**UNITED STATES
NUCLEAR REGULATORY COMMISSION**

SUBJECT: REQUEST FOR A WRITTEN RESPONSE TO NRC OBSERVATIONS AND CONCERNS REGARDING DRESDEN STATION RESPONSE PLAN FOR EXTERNAL FLOODING EVENTS

DRESDEN STATION UNIT 2

May 7, 1982

Figure 18. Fetches for Wave Generation

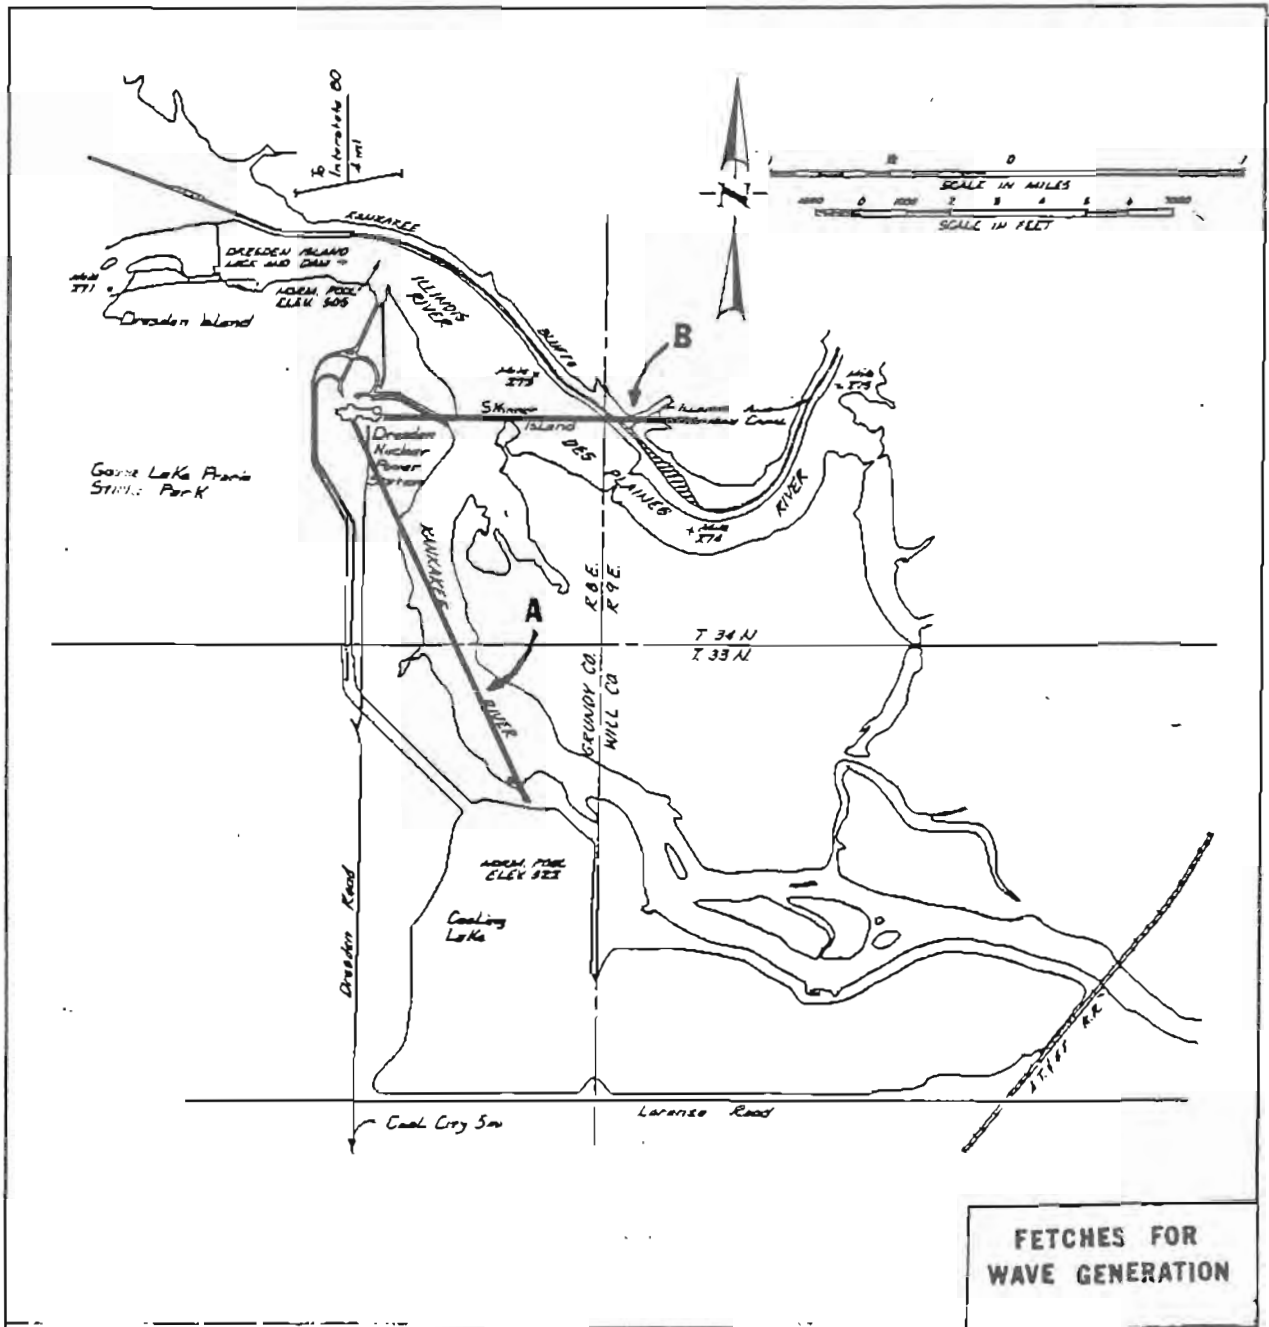
The highest wind speed with a 2-year frequency of occurrence is 50 miles per hour. Two fetches were investigated: one to the southeast of the plant in the Kankakee River (designated A in Figure 18) and the other directly east of the plant across the Kankakee and into the Des Plaines River (labeled B in Figure 18). The critical condition is produced by waves generated on the Kankakee River, which would be 2.6 ft high when they reached the Unit 2 safety-related structures. Wave runup reaches 3 feet above stillwater level. This calculation is a conservative estimate based on procedures outlined in the Shore Protection Manual (32). A PMF stillwater level of 524.5 ft plus a 3 ft wave runup results in a PMF level of 528 ft.

Figure 20. Site Drainage Map

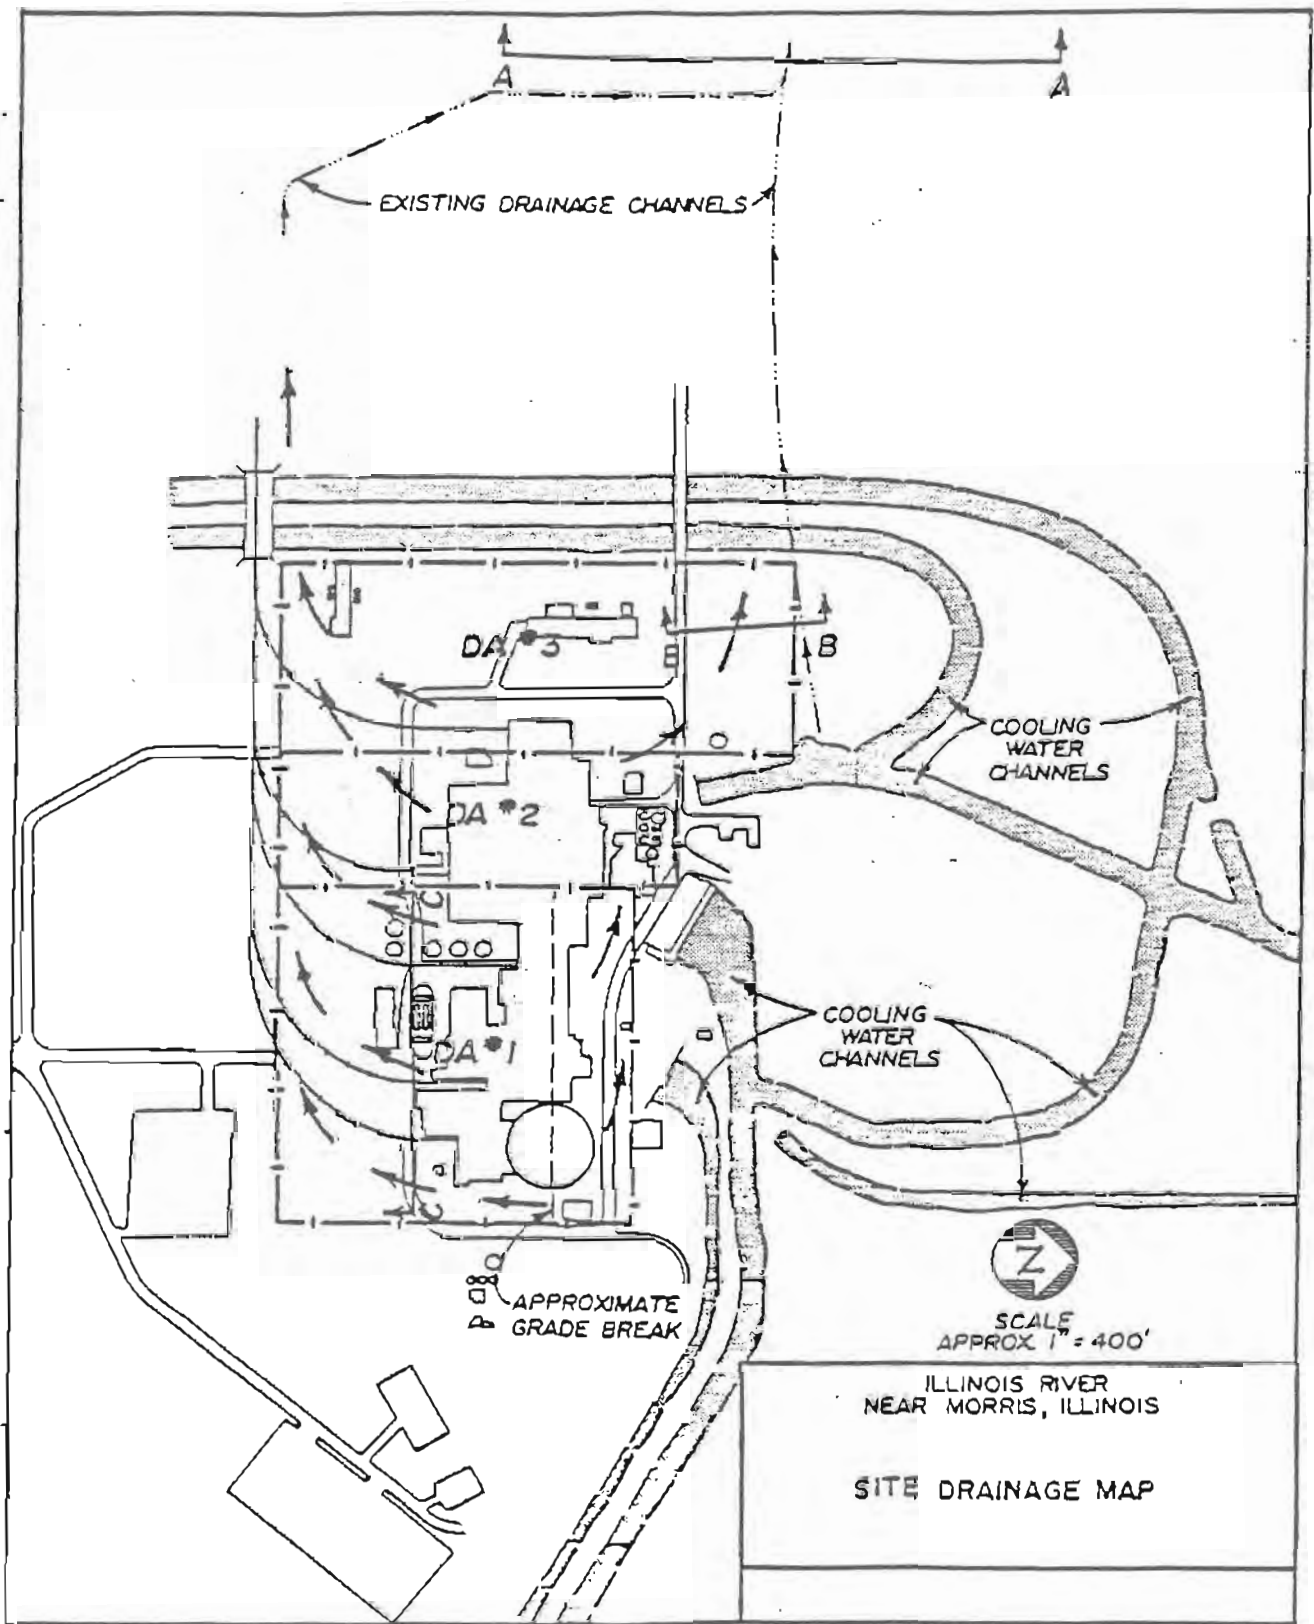
Drainage area No. 1, in actuality, drains both to the north and to the south rather than just to the south as modeled in the first set of calculations. The drainage divide is located north of the east-west midline of the buildings as shown in Figure 20. Approximately 3.1 acres drain to the north and 9.3 acres drain to the south.

A cross section was placed on an east-west line located south of and adjacent to the plant buildings in area No. 1. The location of the section, seen as Section C-C on Figure 20, was selected for several reasons including its proximity to the buildings, the large surface area adjacent the section occupied by the buildings, and the lack of defined drainage swales or channels. The cross section can be described as a broad, flat, flood plain and represents the worst-case situation.

The hydraulic analyses show that the water surface elevations created by the onsite PMF will not exceed the finished floor elevation of the plant. The analysis revealed that the slope of the land surface was sufficient to carry away runoff generated from high intensity rainfall equivalent to the PMP without the flood level exceeding elevation 517.5 ft msl.

Figure 21. Critical-Time Hydrograph for the Illinois River

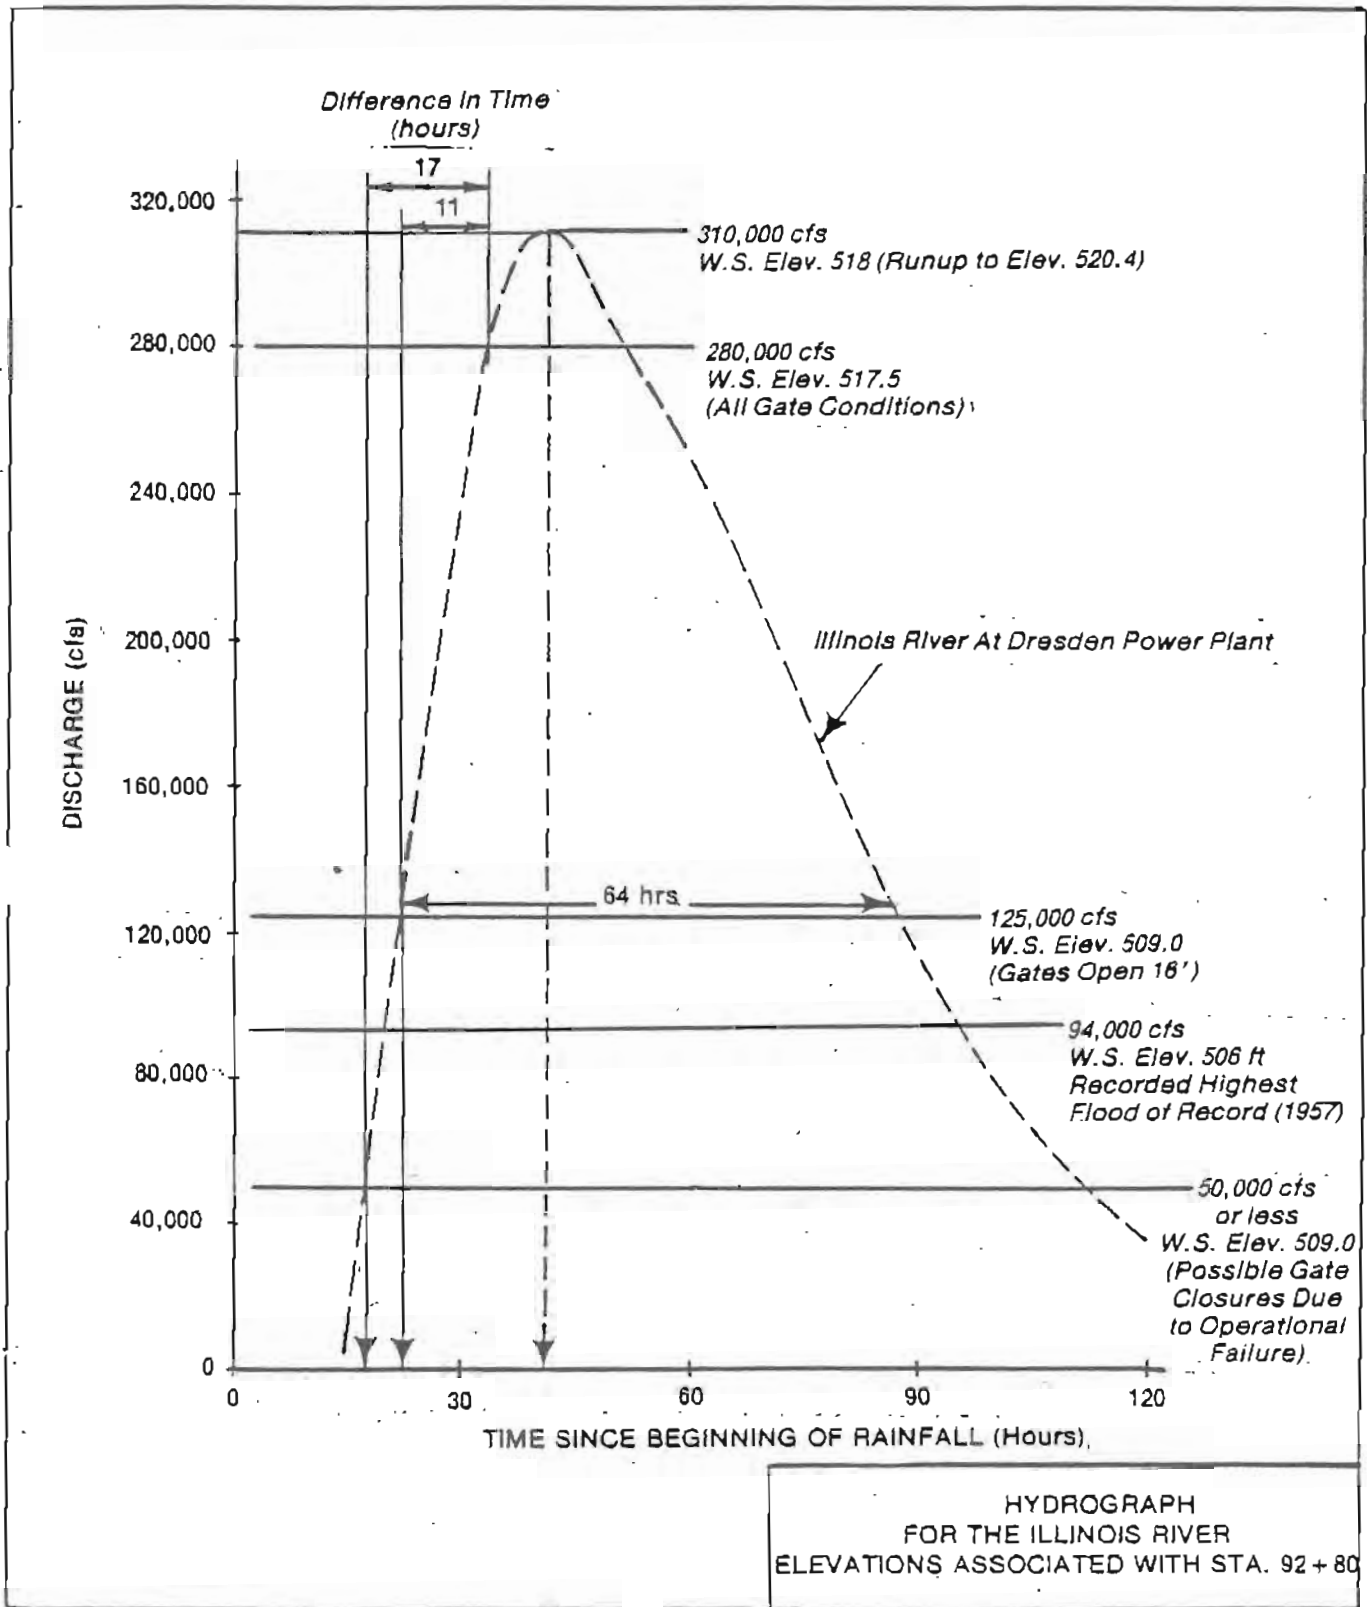
The critical-time flood hydrograph shown in Figure 21 graphically depicts the relationship of flood elevation to time (hours) since the beginning of the limiting rainfall event. The following information can be obtained from the critical-time hydrograph.

- o For low elevations (i.e., small discharges), the configuration of tainter gates at Dresden Dam has a great effect on stream elevations.
- o Assuming gates open to 16 ft, 22 hours will be available from the onset of rain until the Illinois River reaches the elevation of the service water pumps (509 ft msl).
- o Assuming gates open to 16 ft, 33 hours will be available from the onset of rain until the Illinois River reaches elevation 517.5 ft msl (plant grade).
- o Assuming gates open to 16 ft, flood waters will be above elevation 509 ft msl for approximately 64 hours (2.75 days), and for a longer time during the PMF.
- o Assuming gates open to 16 ft, flood waters will rise from elevation 509 to 517 ft in approximately 7 hours during the PMF.

A flood emergency procedure should anticipate a flood which threatens the site sufficiently in advance of the occurrence of the flood to allow adequate time to place the plant in a safe shutdown condition (cold shutdown). Ideally, this shutdown procedure should be accomplished using normal shutdown procedures within approximately 28 hours (4 hours condenser cooling plus 24 hours reactor shutdown cooling system). However, presuming a rapid rise of water which hampers the operation of normal cooldown mechanisms, the emergency procedure should also identify the alternate cooldown plan and elaborate upon the mechanisms and equipment used in the alternate cooldown procedure.
